591, 593 COBBITTY ROAD &
1 FRESHWATER DRIVE, COBBITTY
(PRECINCT 2A STAGE 1 &
TRANCHE 5a STAGE 1)
ROAD & DRAINAGE DESIGN

ISSUED FOR SUBDIVISION WORKS CERTIFICATE

WORKS AS EXECUTED
WORKS AS EXECUTED INFORMATION SHOWN IN RED.
DATE: 15/09/2025

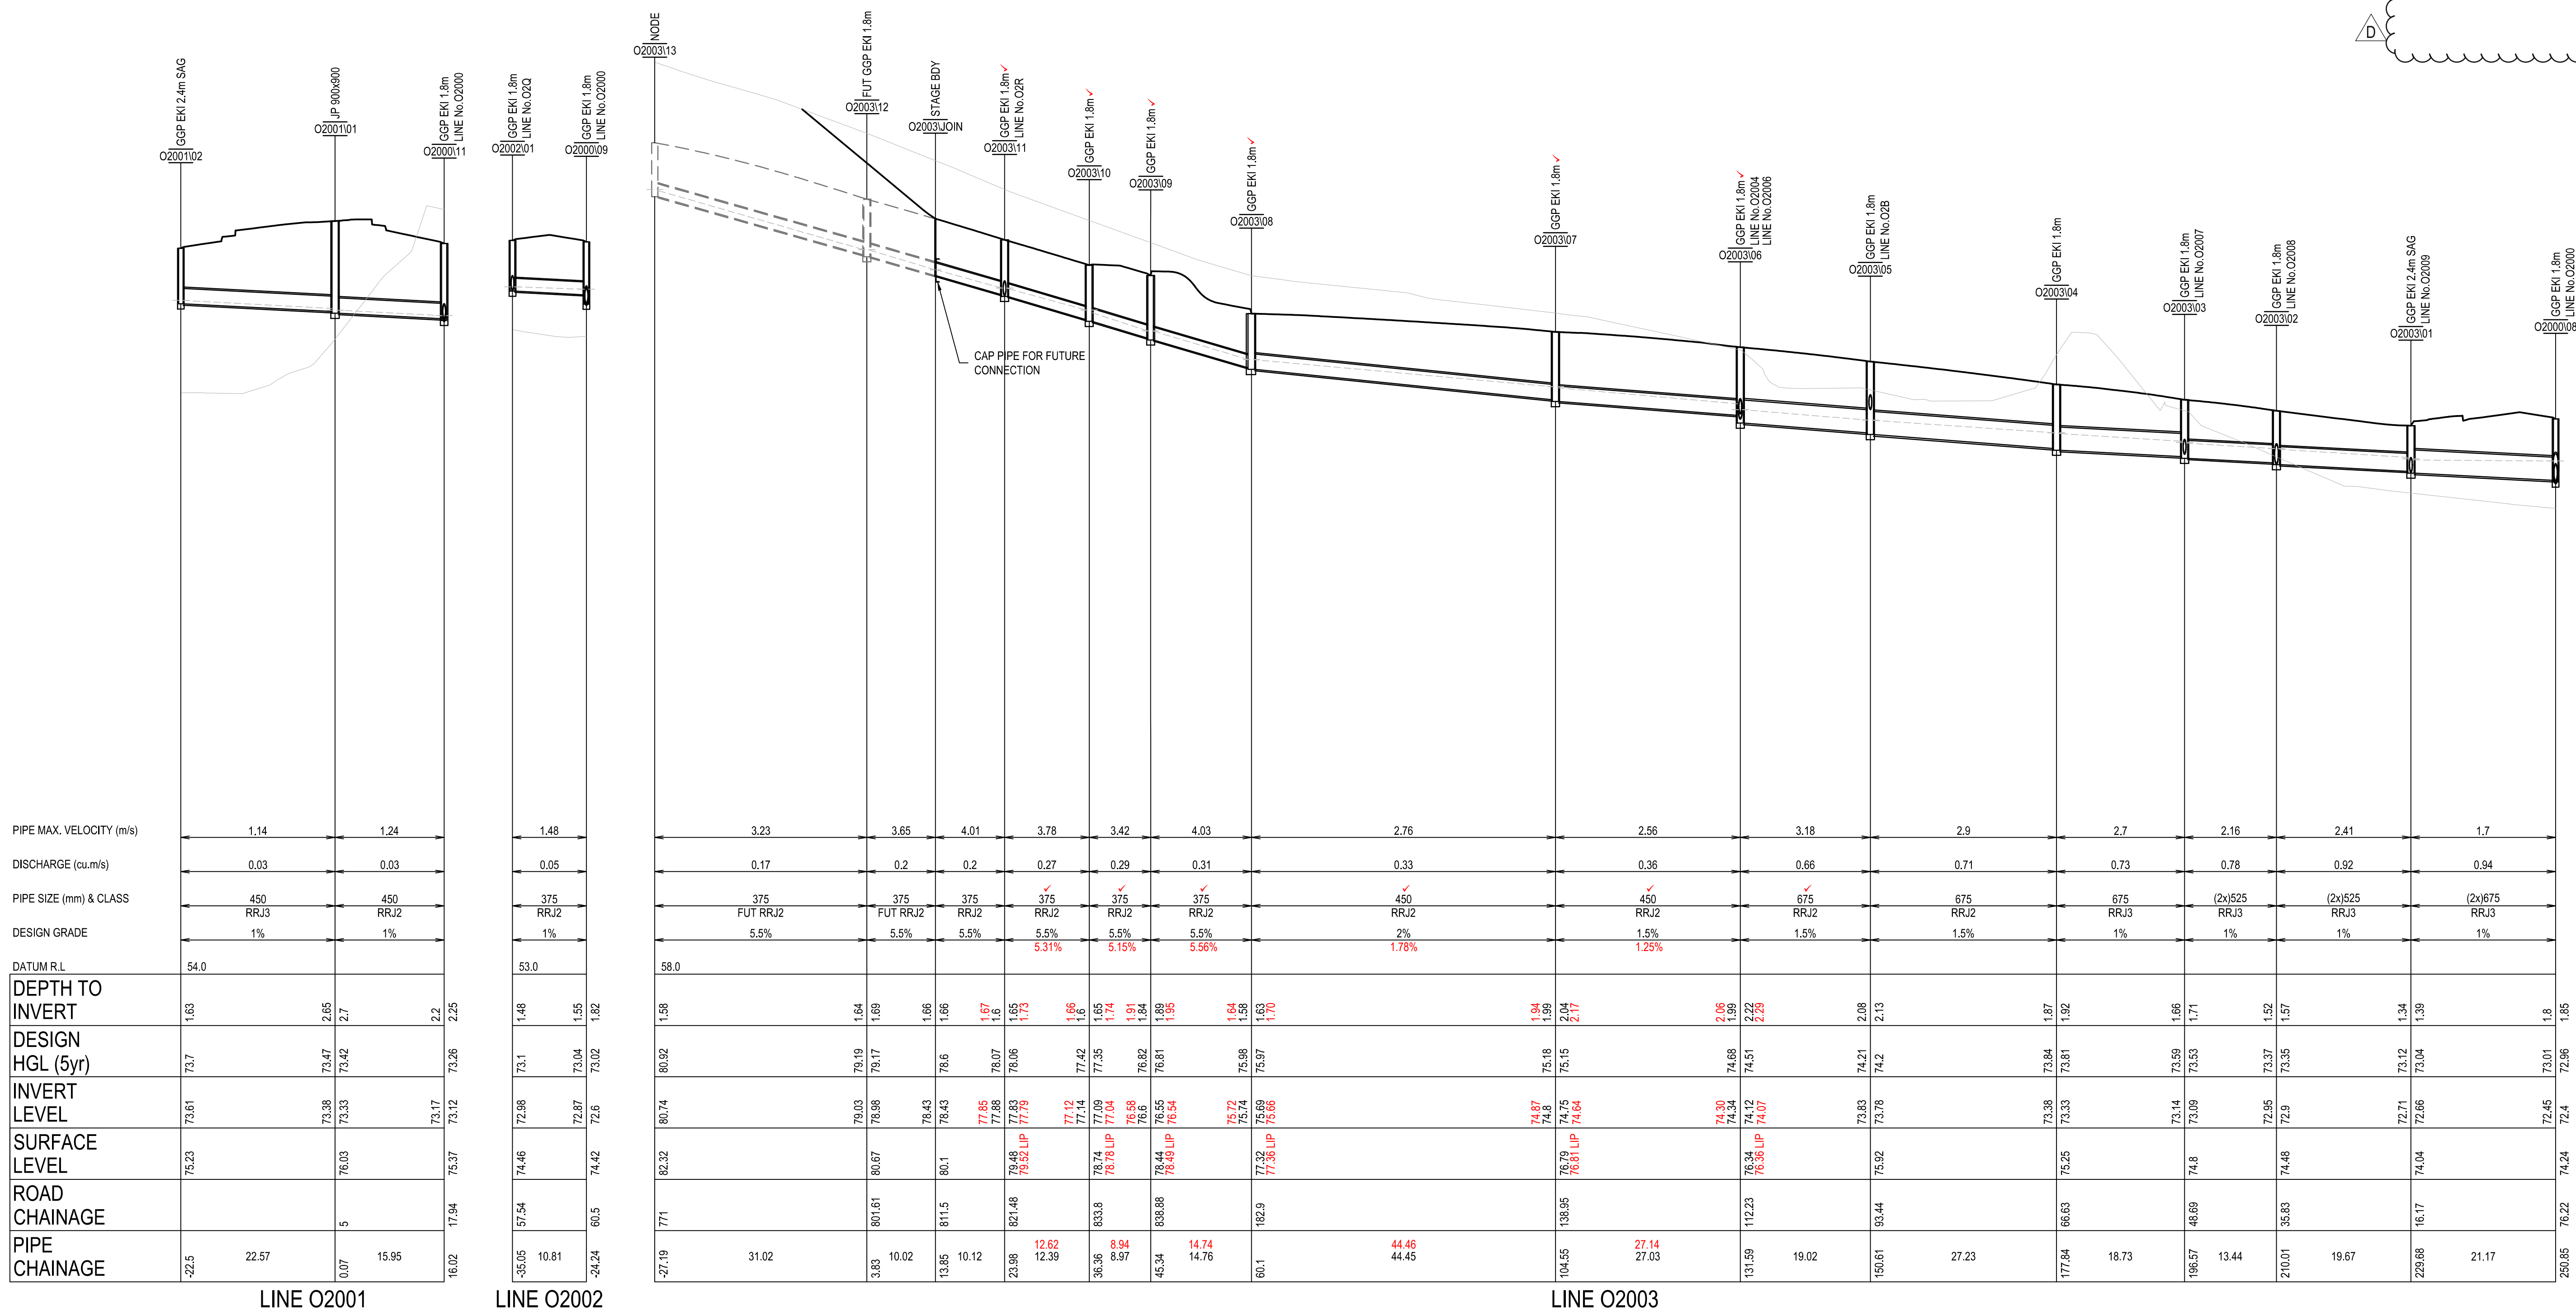
- *PIPE O2000 UPSIZED
- *PIT NUMBERS AMENDED
- *HGL LOWERED

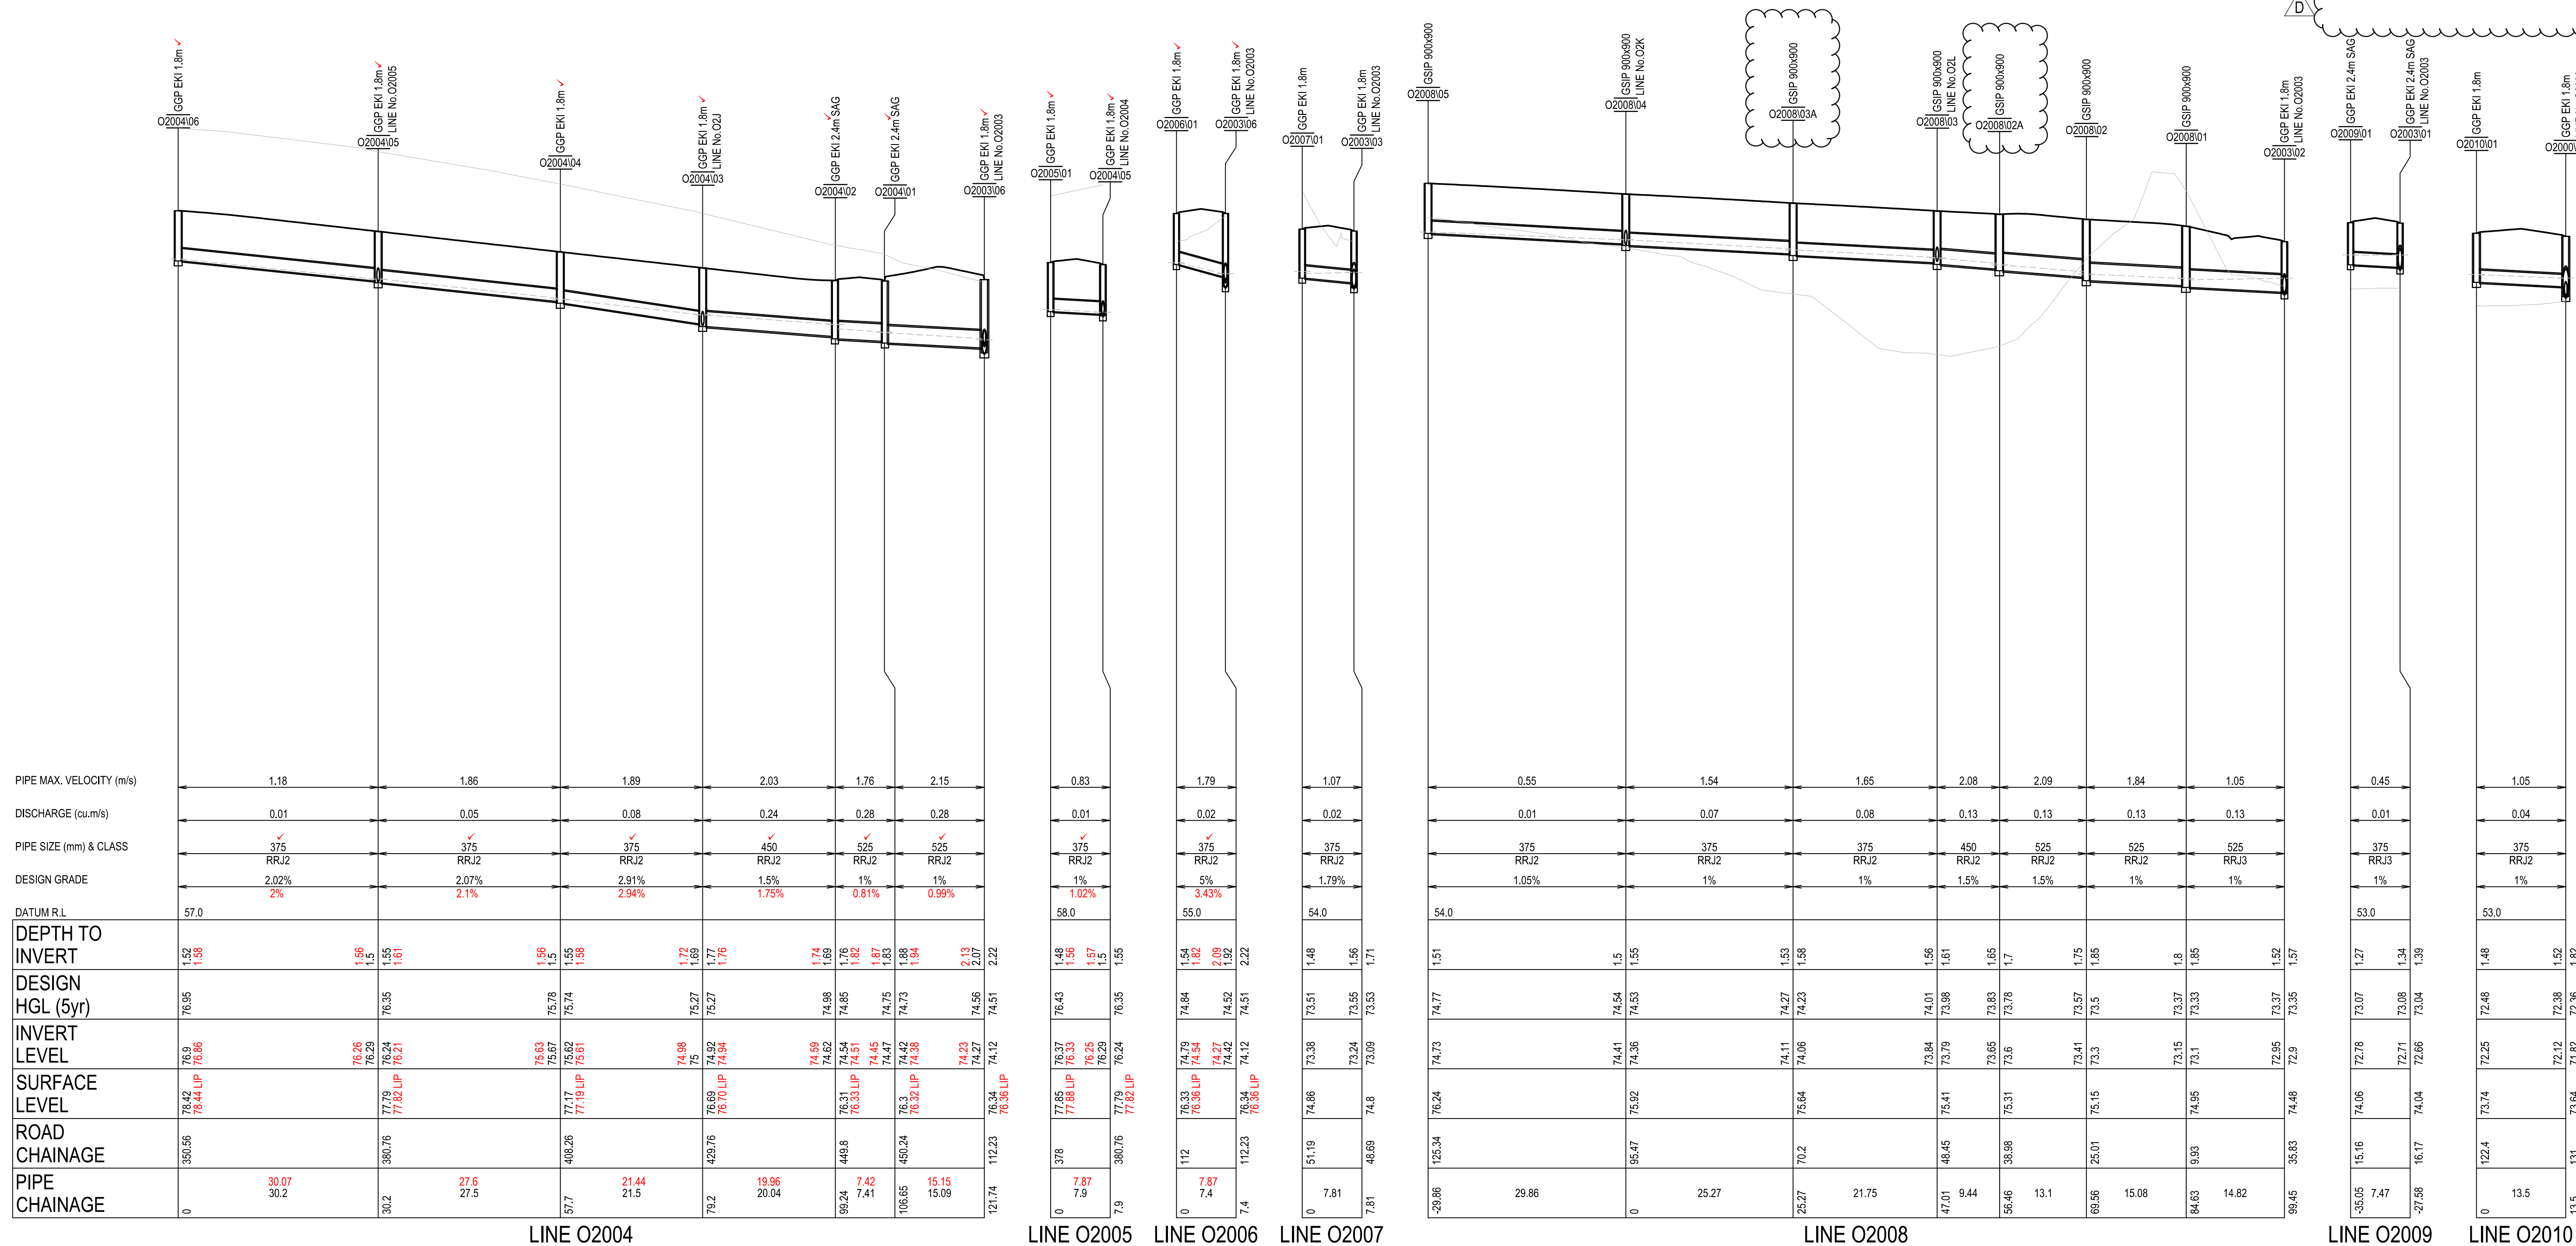
- *PIPE O2000 UPSIZED
- *PIT NUMBERS AMENDED
- *HGL LOWERED

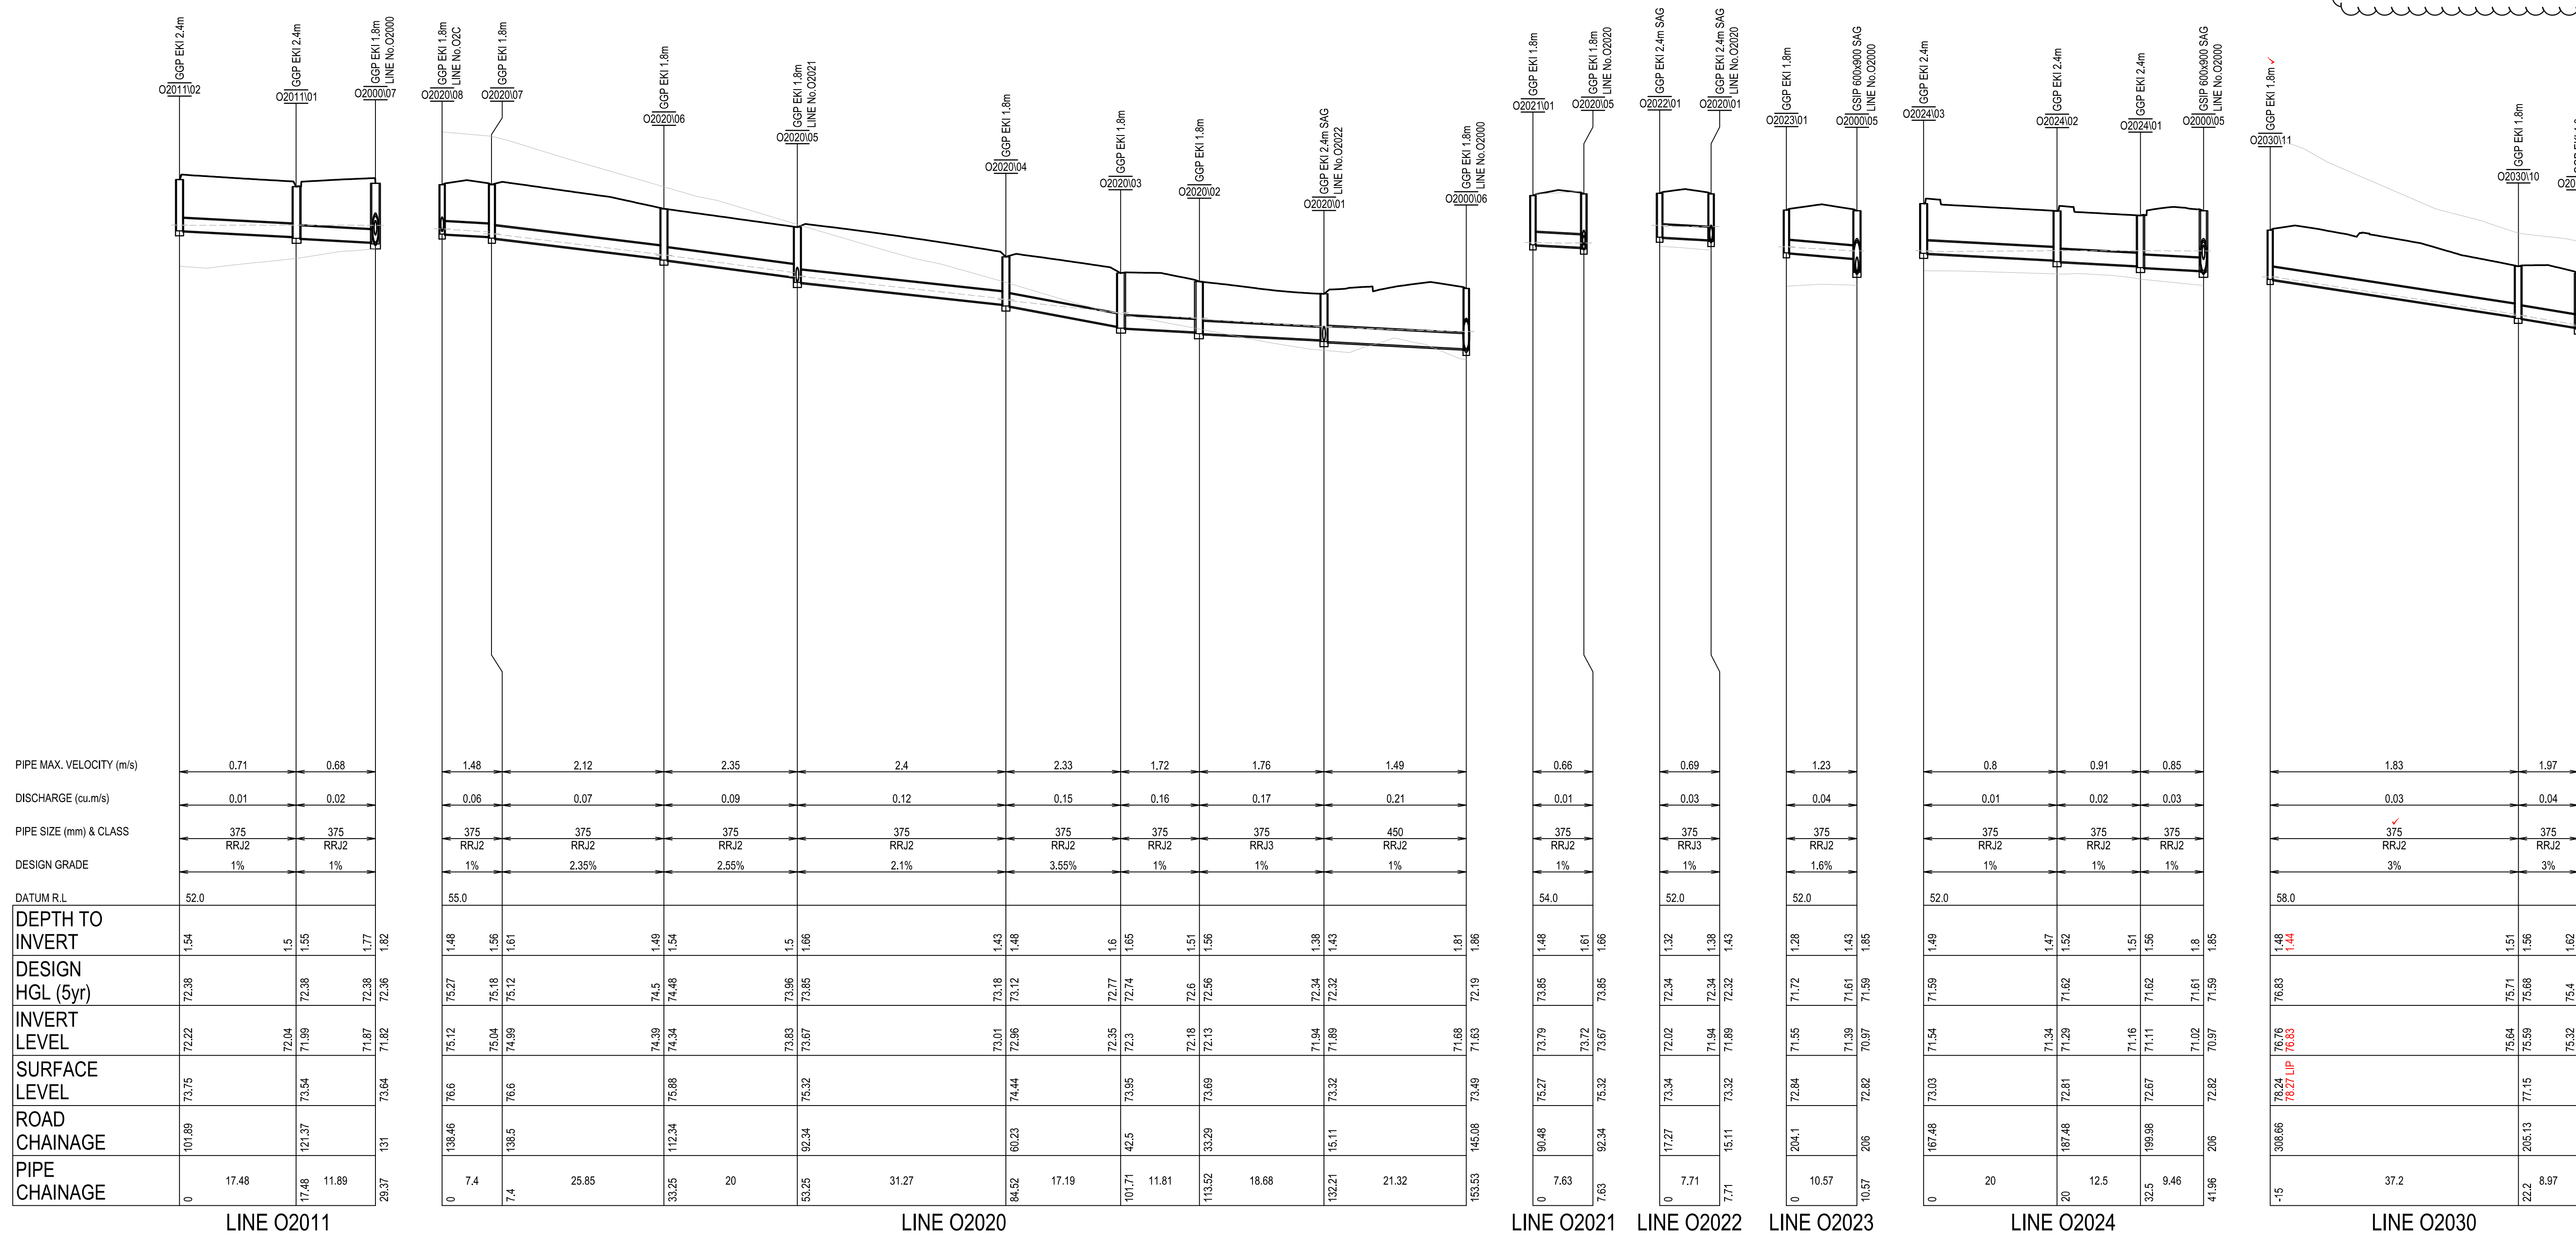
- *PIPE O2000 UPSIZED
- *PIT NUMBERS AMENDED
- *HGL LOWERED
